Review of Regressive Channel Erosion and Grade Control Options on the Rio Coca, Ecuador

PURPOSE: The US Army Corps of Engineers (USACE) is assisting the Ecuadorian state-run Corporación Eléctrica del Ecuador (CELEC) in addressing a water resource issue involving regressive channel erosion on the Rio Coca. Reconnaissance of the site was completed the week of 21 February 2022; parts of the river system were viewed to determine if improvements could be made to the current grade control structure (GCS) mitigation plan for reducing channel erosion and stabilizing the river system downstream of the Coca Coda Sinclair (CCS) Dam.

Figure 13. Rio Coca Km 12 location illustrating the existing GCS plan. Image reproduced with permission from CELEC (2021).

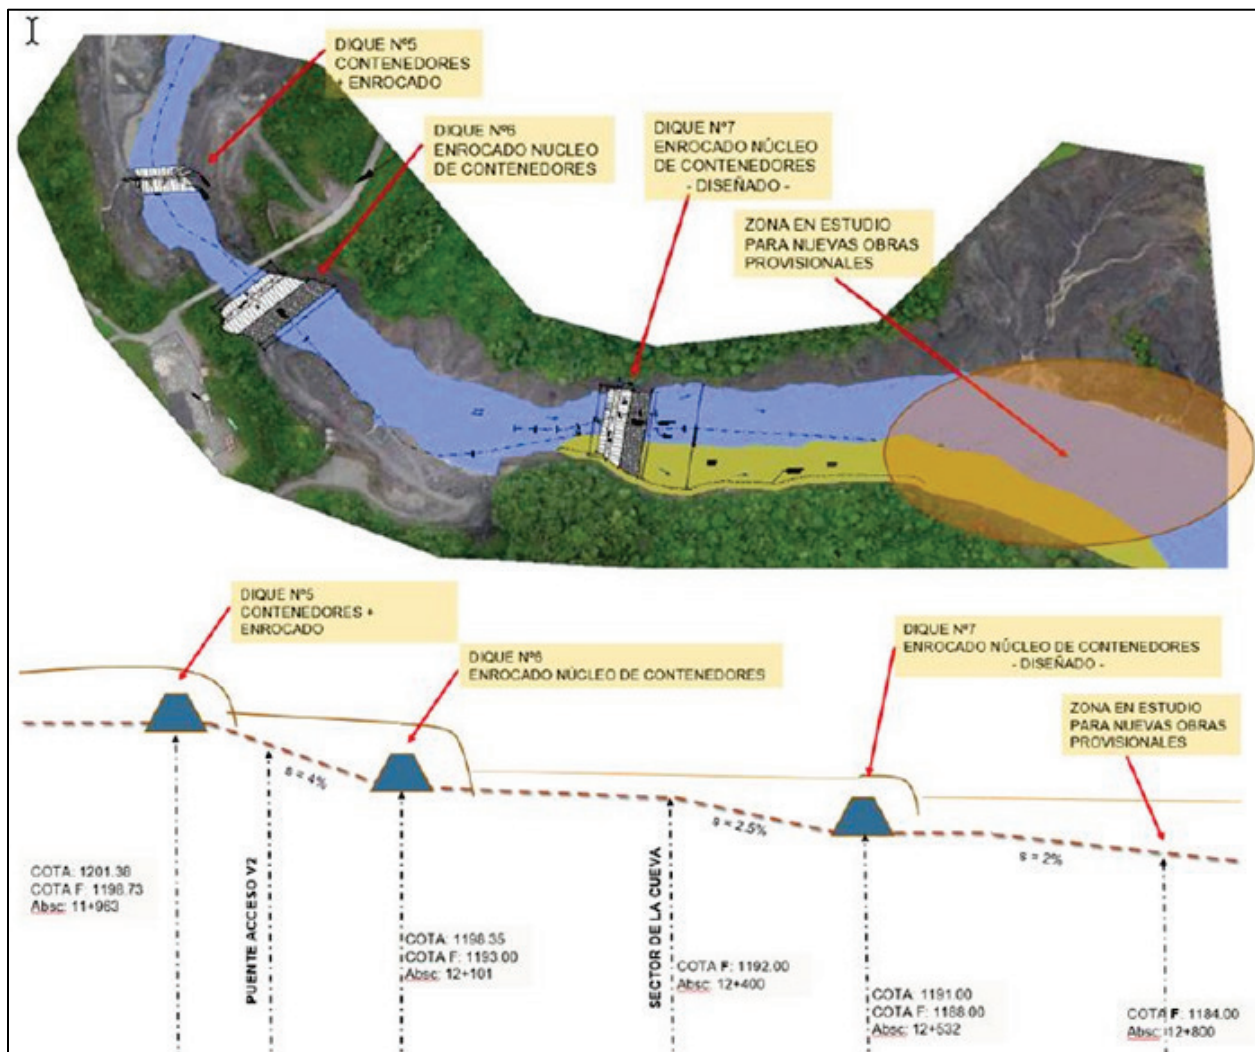
GRADE CONTROL PLAN (EXISTING): A GCS plan was developed and partially implemented in 2021. The plan was to construct a series of four check dams around Km 12 (Figure 13). These are located at San Luis, in a pinch-point in the valley with a high alluvial terrace on the left bank and a resistant valley wall and bedrock on the right bank (Pedro Barrera, pers. comm., February 2022). The Rio Coca is entrenched in the right valley wall materials, and recent field reconnaissance indicated the river appears to be incised 3 m into the breccia materials in this location. At this location, channel degradation is propagating more slowly upstream because the river has encountered more resistant materials, thereby slowing down the regressive erosion process of widening and deepening. However, some of the knickpoints have propagated upstream in the form of knick zone expansion, and the channel has degraded 3 to 5 m upstream (Figure 10 and Figure 14). Once the Rio Coca encounters the less-erosion-resistant alluvial floodplain deposits, channel widening and deepening occurs relatively rapidly, depending on the frequency and magnitude of flow events.

Two check dam structures (CDSs; Figure 13) were constructed in the pinch-point location (i.e., San Luis) to protect from extension of the knickpoint upstream and to protect an existing bridge. Both structures were compromised during a March 2021 flow event of $1600 \text{ m}^3/\text{s}$. The structures were constructed with a solid core and concrete-filled metal containers and were shaped upstream and downstream with large local channel materials. The materials used for construction had a median size of 1.2 m (Pedro Barrera, pers. comm., February 2022). Highly concentrated flow velocities in the pinch-point river section undoubtedly compromised the structure. A structure with a rigid core is typically able to adjust to minor winnowing of materials. However, loss of the structure may occur when excessive foundation scour occurs and the solid core cannot freely adjust; movement of the CDS may occur. The CDS is one form of GCS that is designed with a solid core and uses available onsite materials. There are many other types of GCSs that incorporate similar materials, such as well-graded riprap. The sizing of riprap depends on accurately measuring and predicting channel velocities and shear stresses so that materials can be sized appropriately. The advantage of large and well-graded riprap is that it has launching and rellocking capabilities once the structure or revetment encounters the anticipated velocities and resulting scour. The construction of the CDSs was limited by the requirement to use only locally available rock (i.e., 1.2 m in size) and the limited gradation that was present; these likely caused the structures to be compromised. Flanking of the structure on either bank line, especially in a pinch-point-incised channel location, is also a concern because water depth and channel shear stress increase. These locations were not observed during the site visit.

Figure 15. Rio Malo control dam structure (CDS) profile (*left* is upstream to *right* downstream). Image reproduced with permission from CELEC (2021).

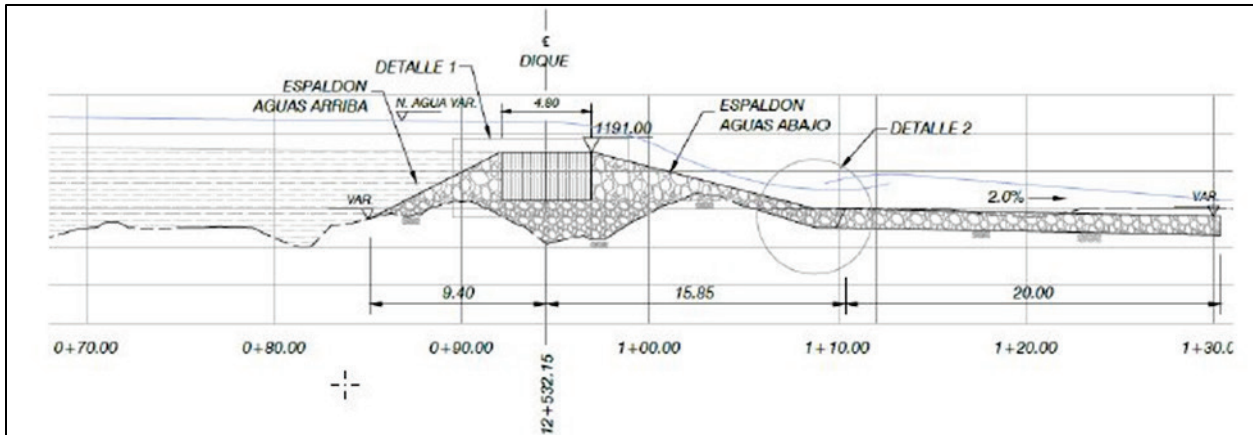
A third CDS (Figure 15) was constructed upstream of the pinch-point at approximate station 9+550 (upstream of La Loma Camp). This structure was viewed during the site visit on 22 February 2022 and appeared to be functioning well (Figure 16). From design information, it appears that the structure was installed as a linear structure perpendicular to flow and did not have a solid core (CELEC 2021). The structure will be tested with the upcoming rainy season (Spring/Summer 2022).

It is not known why the two CDSs were compromised, but some enhancements to the designs will increase the likelihood of success. The extreme shear stress and velocities in the pinch-point likely produced sufficient energy to compromise the structures in some way, whether it was flanking, material removal movement (approximately 1–1.2 m sizing) around the solid core, or a combination of both. Possible enhancements to the structure designs are provided in the next section.

3. Using local materials with limited size and gradation to continue to construct the CDS would provide some local protection but would only slow down, rather than halt, the channel degradation. Some enhancements to the structure design would be to slightly V-shape the structure upstream, with a lower elevation at the center of the V. This would allow upstream flow to concentrate in the center of the channel and away from the potential of flanking at the bank lines. If using large boulder materials (i.e., well-graded material sizes based on velocity/shear stress calculations), the center could be built with an invert elevation notch, with increasing elevation in the direction of each bank line. This would provide some level of protection as the knickpoints migrate upstream, concentrating the degradation in the center of the channel and not around the sides where it will encounter less-resistant alluvial and terrace deposits. The V-shape could be modified to either side of the channel, depending on planform characteristics or promoting channel locations away from the alluvial terraces. Best practice would be to reinforce the center, where the velocities and shear stresses are high, with larger materials in the crest and the downstream plunge pool. The more rock placed on the backslope of the structure, the better as degradation progresses upstream to the structure apron. Mimicking natural cascades and falls at the structure locations would provide the greatest energy dissipation and a local stable slope. Examples of reestablishing high-gradient channel stability after flood events or for wildfire recovery are common in the Western United States (Figure 19). Concepts and designs from these stabilization projects could be applied on the Rio Coca.

Figure 17. Longitudinal channel profiles based on separate lidar collection dates (2/2/2020 is *blue*, 9/4/2021 is *yellow*, 9/15/2021 is *green*, and 1/5/2022 is *brown*). Potential Rio Coca stabilization grade control plan (Km 7.8–12.5).

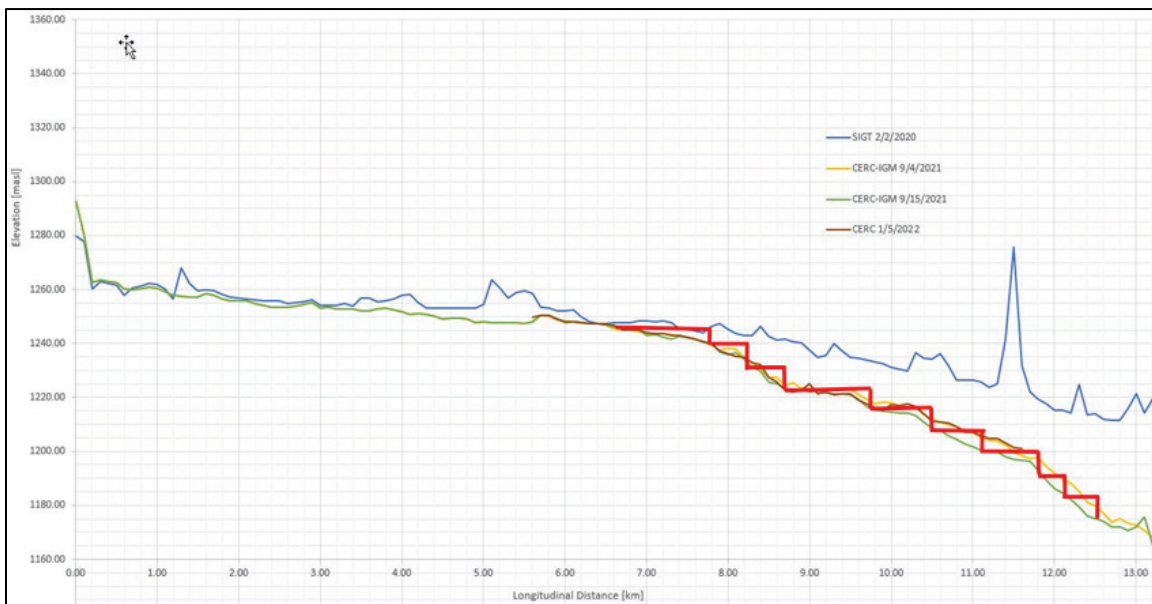
1. A system-wide approach to grade control would start downstream of the existing knick zone at San Luis and work upstream to stabilize the channel slope (Figure 17). Based on the existing lidar profile surface, there is the potential to construct nine GCSs, ranging from 5 to 10 m in height, to stabilize the channel from Km 7.8 to 12.5. This would likely be extended downstream to the previous San Rafael Waterfall location if access to the river corridor can be established. A road is currently being constructed downstream of San Luis and could be used to provide access for construction of a series of structures below the existing knick zone. This would provide additional protection from continued degradation migrating from the downstream reaches. The exact height, width, and location of structures need to be field verified.

Figure 18. Rock excavation and placement to prevent further downcutting; example is at Km 14. Image adapted from CELEC (2021).

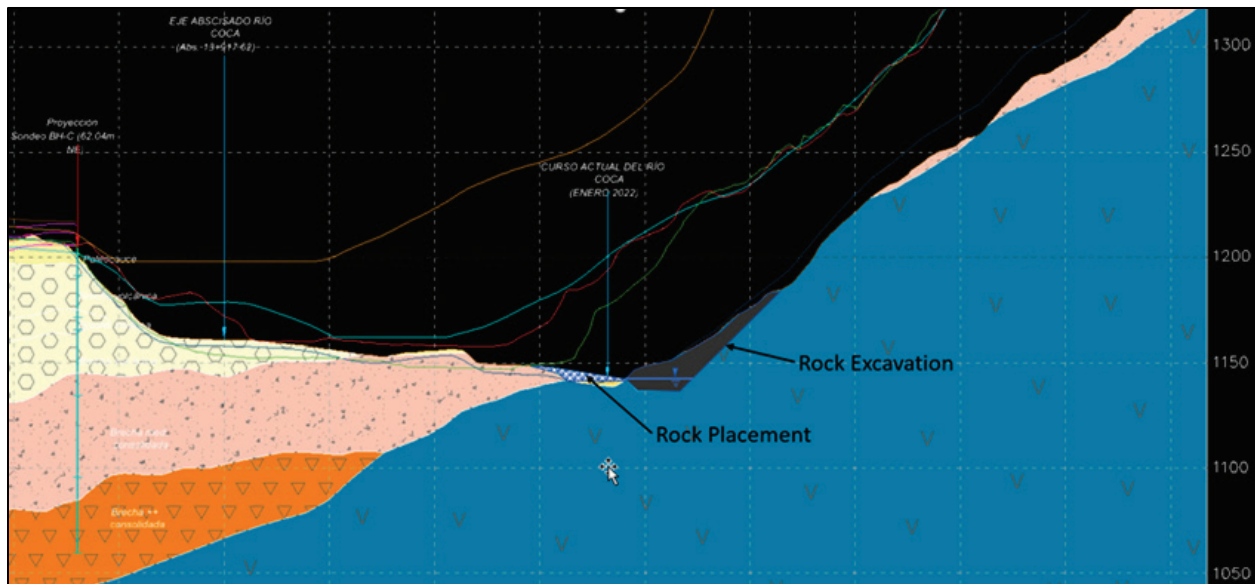
2. The hard-point locations at Km 7 (Walking Bridge), 12 (San Luis Bridge knick zone), and 14 (downstream of San Luis) should be used to continue the system-wide approach to stabilizing the Rio Coca. After the February 2022 trip, discussions at USACE (Figure 18) centered on possibly blasting and using local bedrock sources to stabilize the channel in these locations. This could possibly be extended to other locations where the harder bedrock materials are present.

Figure 20. Example revetment key or tieback to prevent structure flanking.

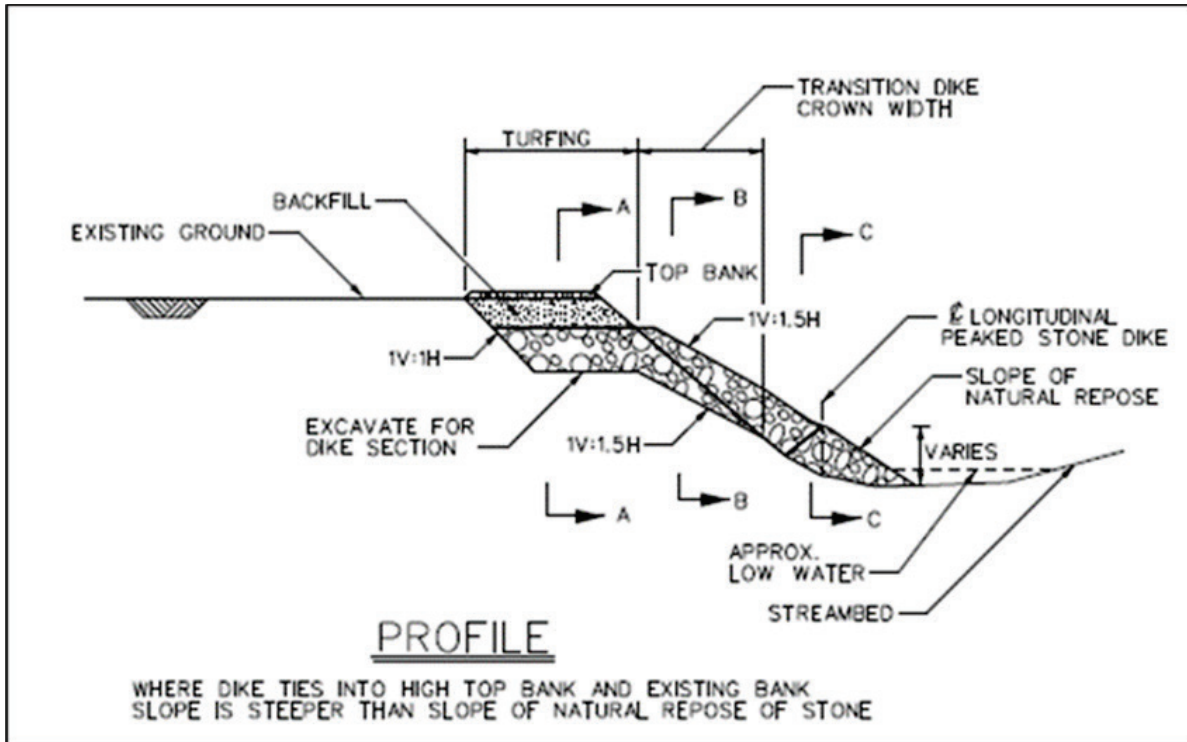
4. Keys or tiebacks into both bank lines should be extensive at each structure (Figure 20 and Figure 21). If there is a high terrace at the revetment location, the tieback can be lowered so that construction does not have to be completed to three-fourths of bank height. Each site will likely have different characteristics and should be assessed independently.
